Re: NH SEC Docket No. 2015-04: Public Service Company of New Hampshire d/b/a Eversource Energy (“PSNH” or the “Applicant”) for a New 115 kV Transmission Line from Madbury Substation to Portsmouth Substation.

NH PUC Docket DE 16-441, DE 16-442: Revisions to PSNH’s Petitions for Licenses to Construct and Maintain Electric Lines, Neutral Wire and Fiber Optic Cable Over and Across Public Waters and Public Lands of New Hampshire

Revisions to the
NHPUC Public Water and Public Land Crossing
License Applications

SUMMARY
Revisions between Originally Submitted Petition
And Revised Engineering Design

SEACOAST RELIABILITY PROJECT
STRUCTURES #123-129
STATE OF NH PROPERTY CROSSING

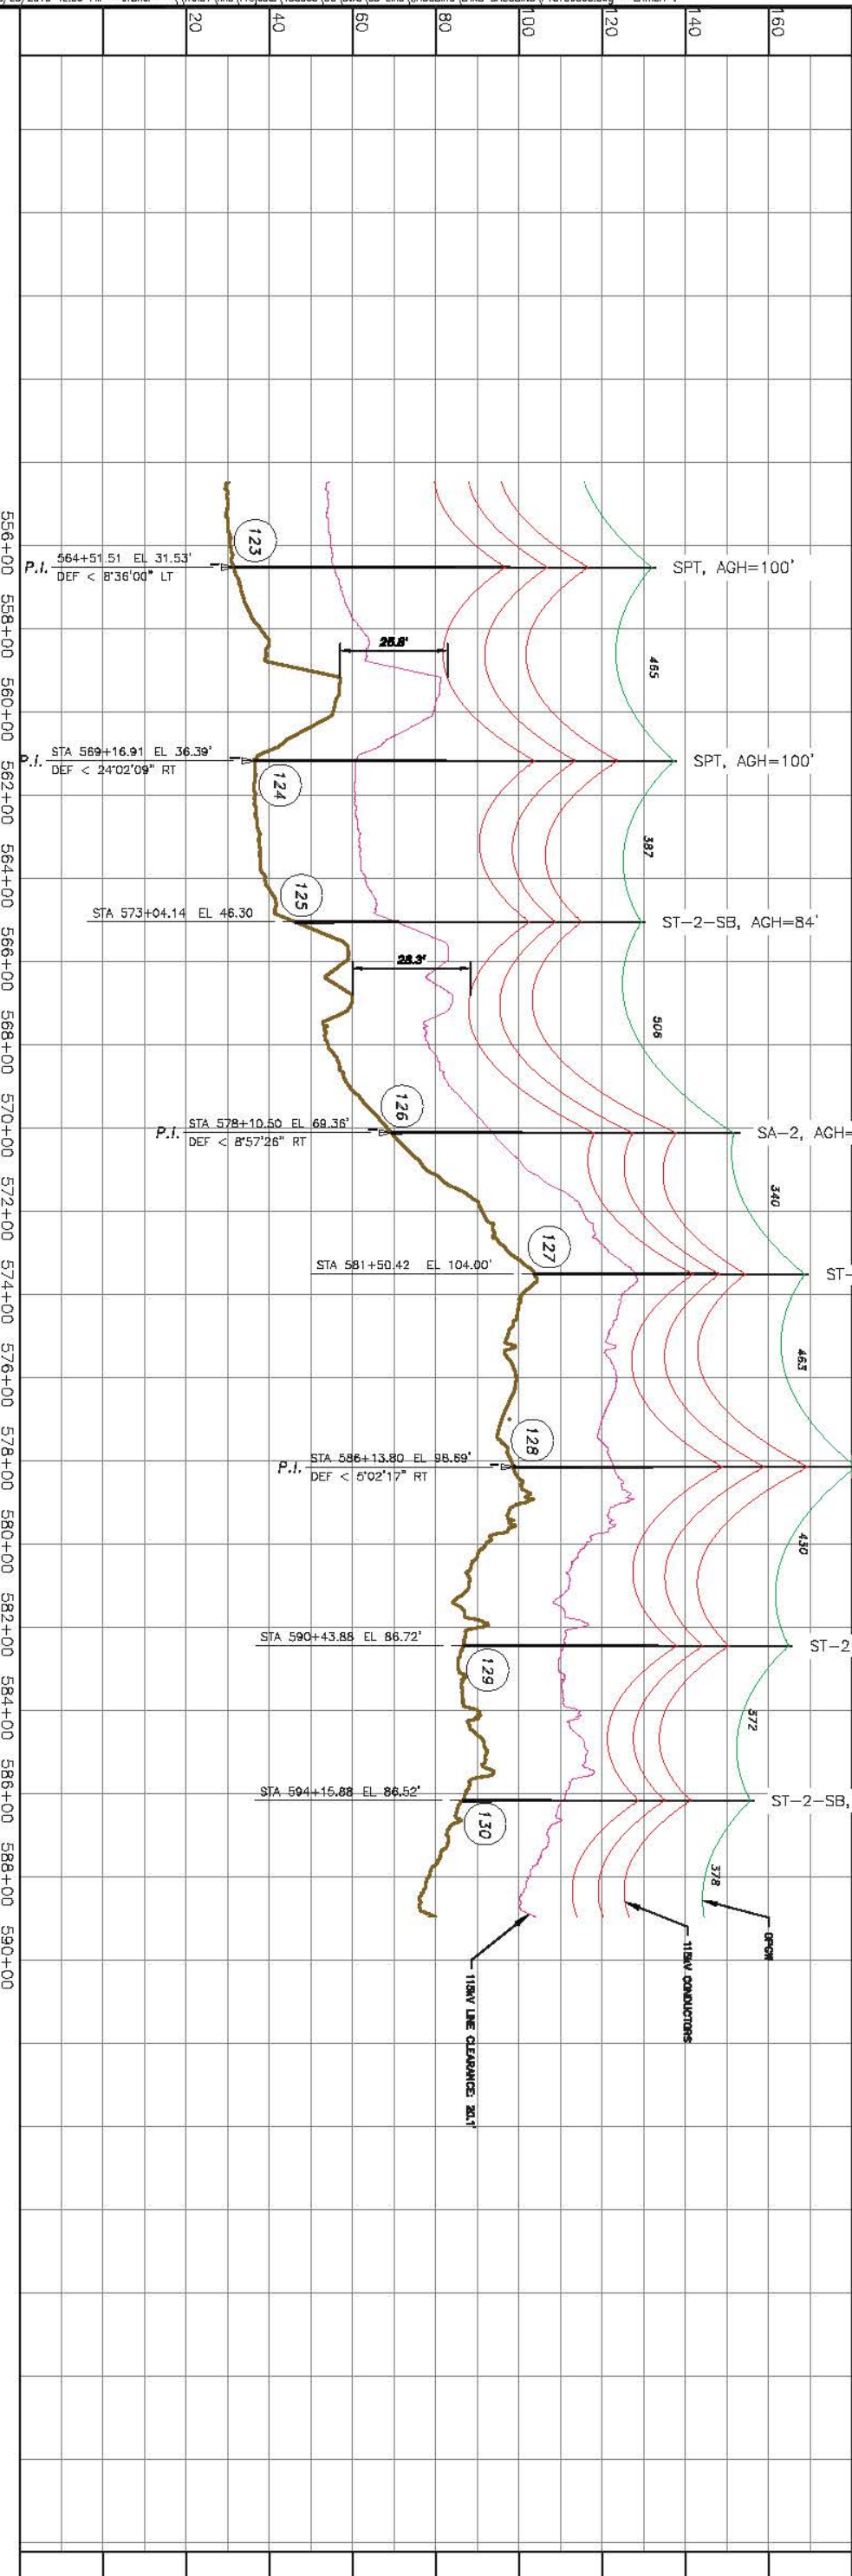
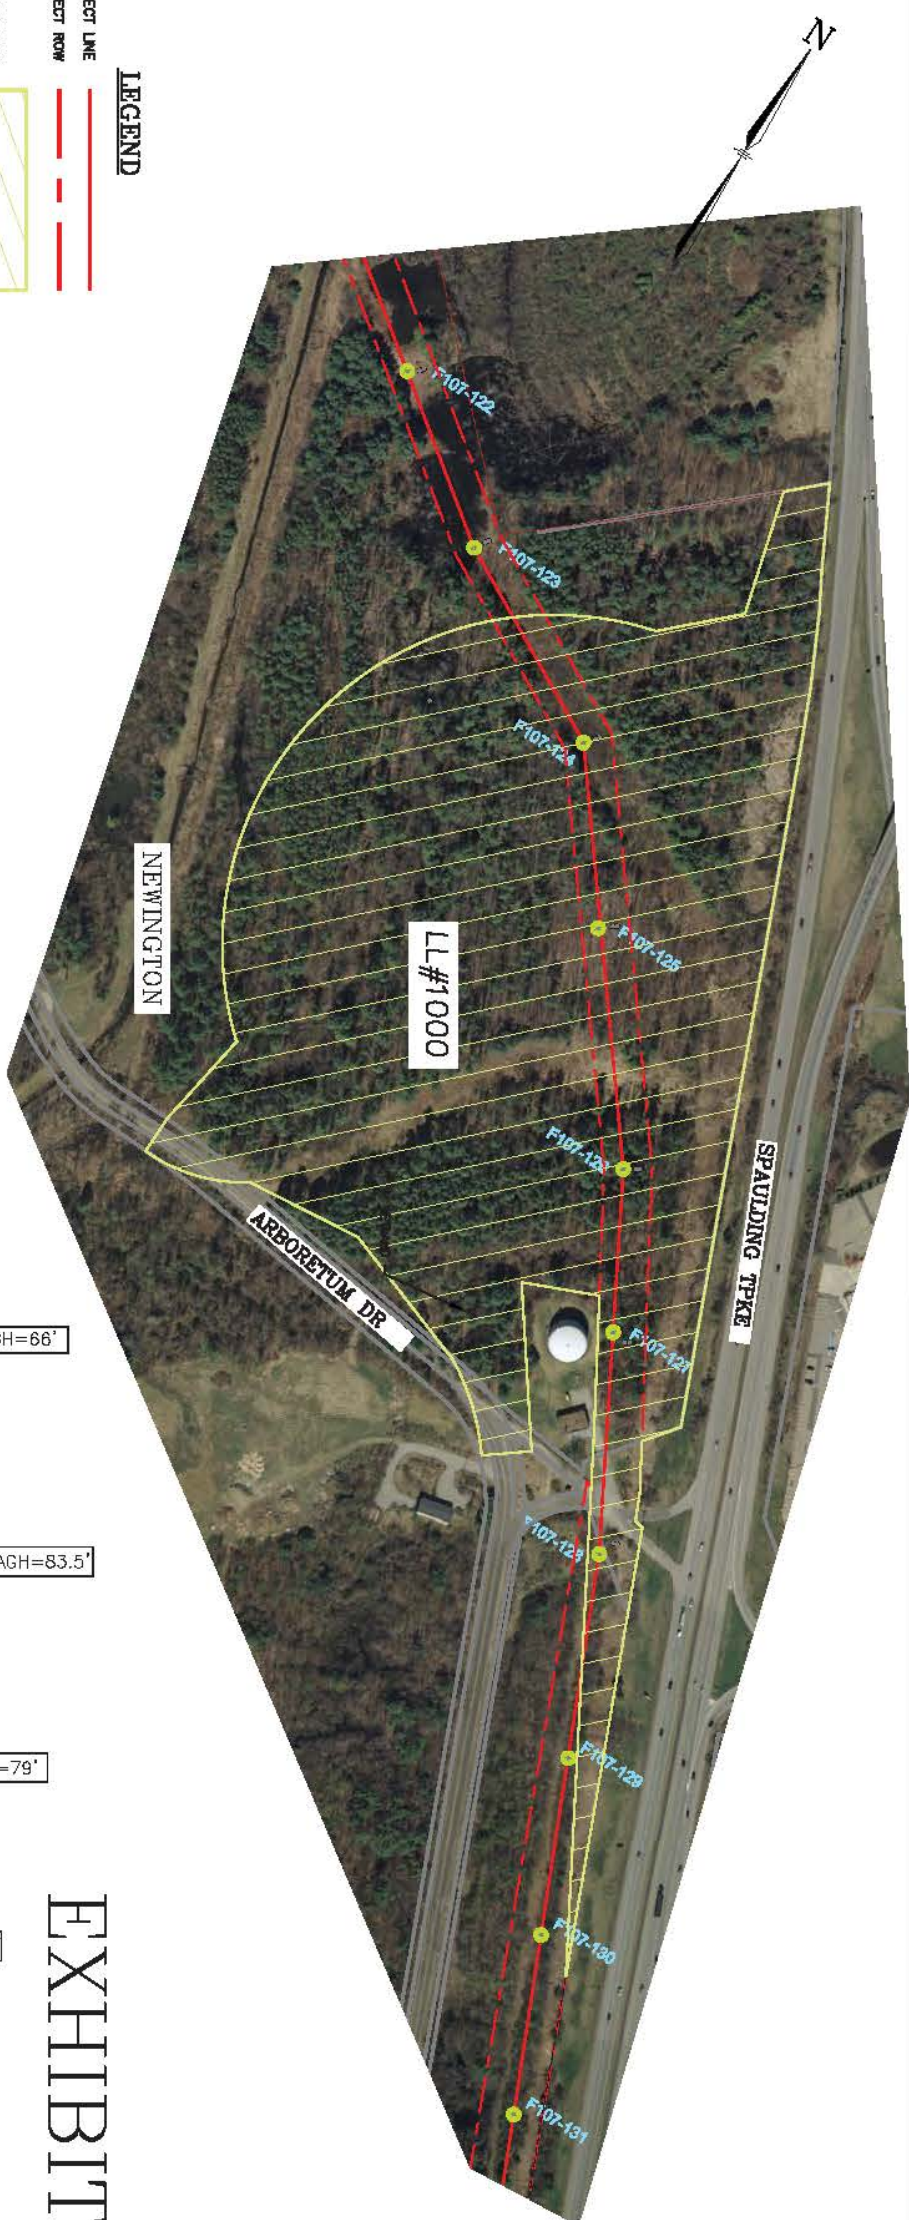
1. Paragraph #1- Revised Drawing number F10799006 (Exhibit 7) has been supplied. No changes to location plan (Exhibit 6).
2. Paragraph #3- **Change** “WT-2-UB”, “SPRA-BP” and “WA-2” to “ST-2-UB”, “SPT” and “SA-2” respectively.
3. Paragraph #3 - **Change** “7-15.5 feet” to “7-12.5 feet”
4. Paragraph #3 - **Change** “nine inches” to “six inches”
5. Paragraph #3 - **Change** “ten feet” to “10.25 feet”
6. Table 1 Column 3- **Change** 15.5 feet to 18 feet
7. Paragraph #5- **Change** “water” to “land”
8. **Replace** Table 3 with revised table below

<p>SEACOAST RELIABILITY PROJECT STRUCTURES #131-133 STATE OF NH PROPERTY CROSSING</p> <p>SCALE: H 1"=800', V 1"=20'</p> <p>DATE: 01/22/16</p>		<p>T 1</p> <p>2</p>

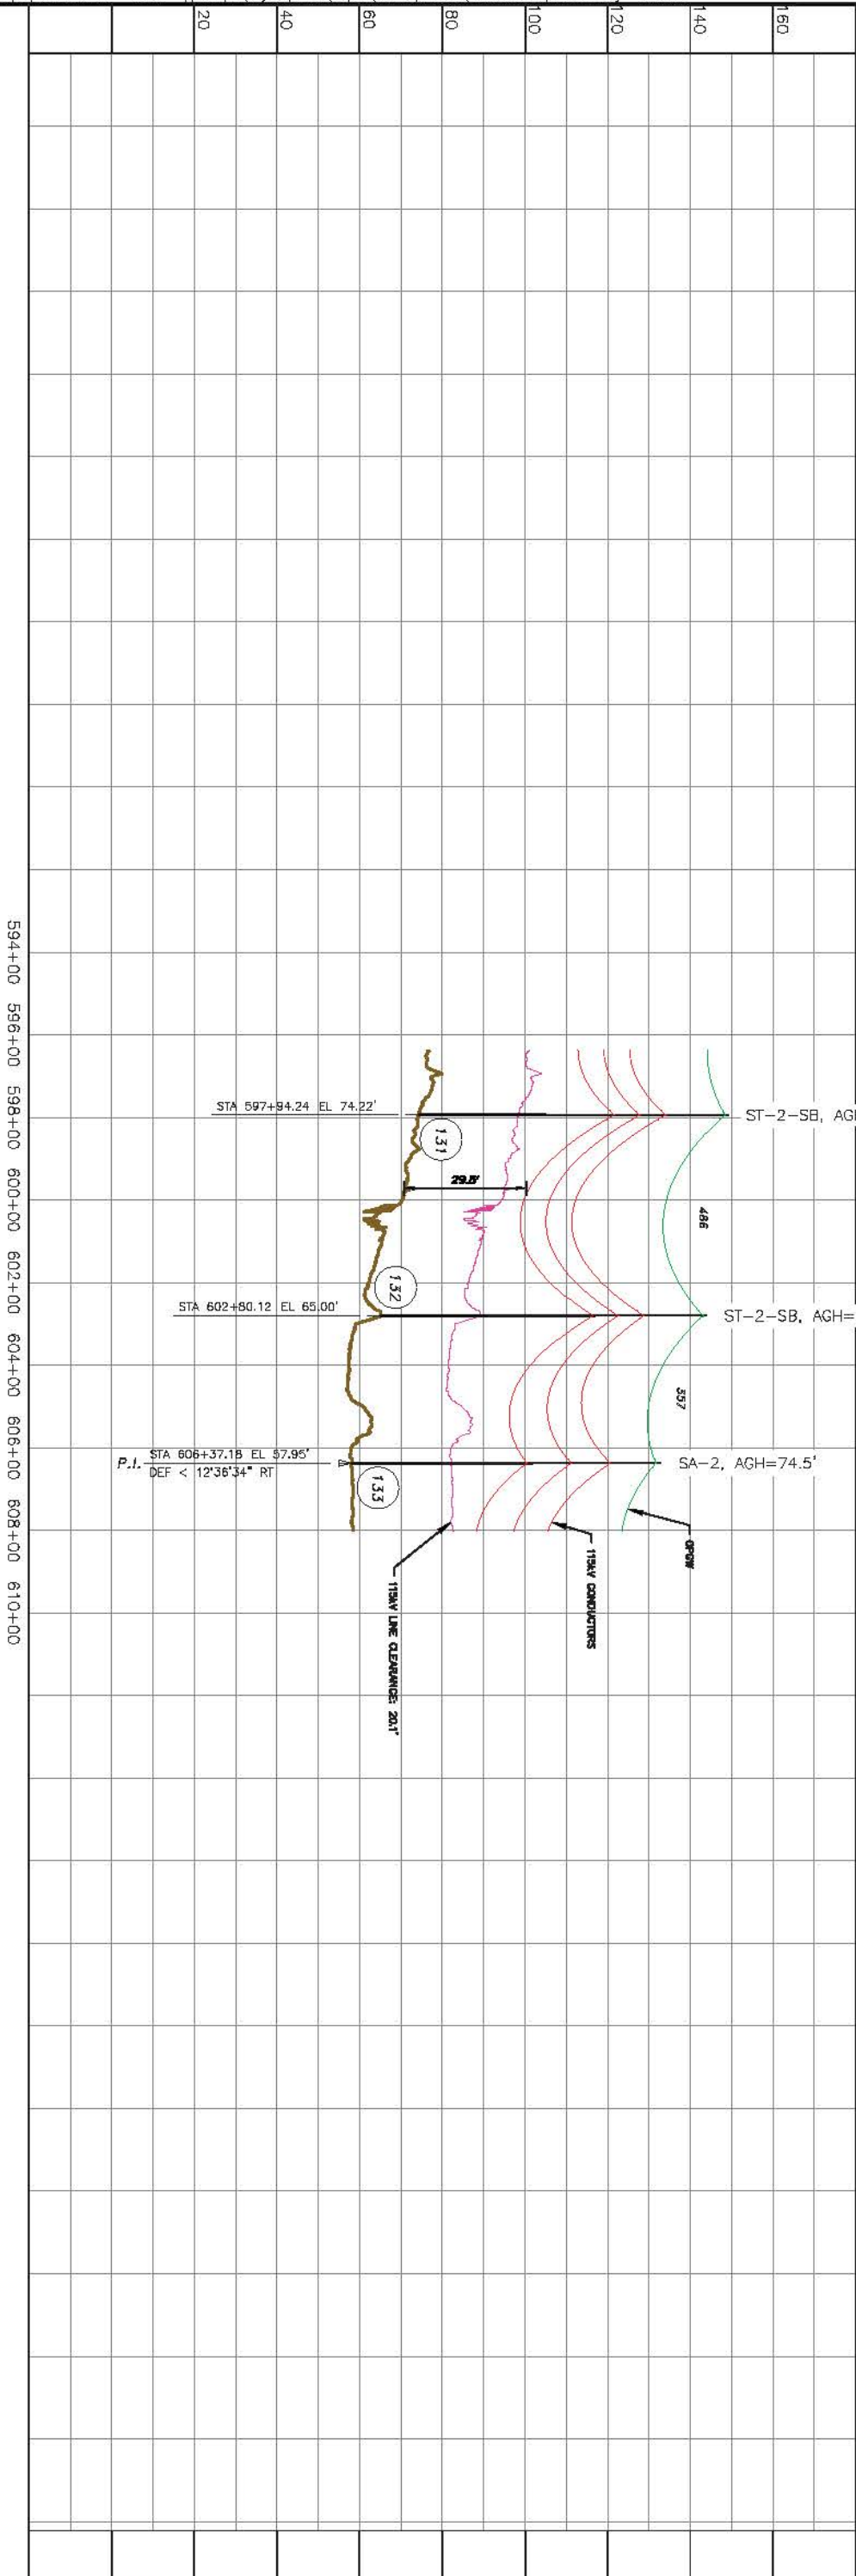
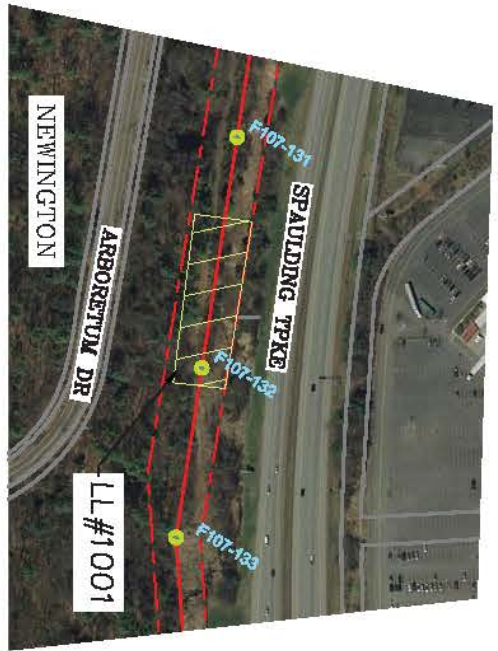
1. Paragraph #1- Revised Drawing number F10799008 (Exhibit 9) has been supplied. No changes to location plan (Exhibit 8).
2. Paragraph #3- **Change** “WT-2-UB” and “WA-2” to “ST-2-UB” and “SA-2” respectively.
3. Paragraph #3 - **Change** “7-15.5 feet” to “7-12.5 feet”
4. Paragraph #3 - **Change** “nine inches” to “six inches”
5. Paragraph #3 - **Change** “ten feet” to “10.25 feet”
6. Paragraph #5- **Change** “water” to “land”
7. **Replace** Table 3 with revised table below
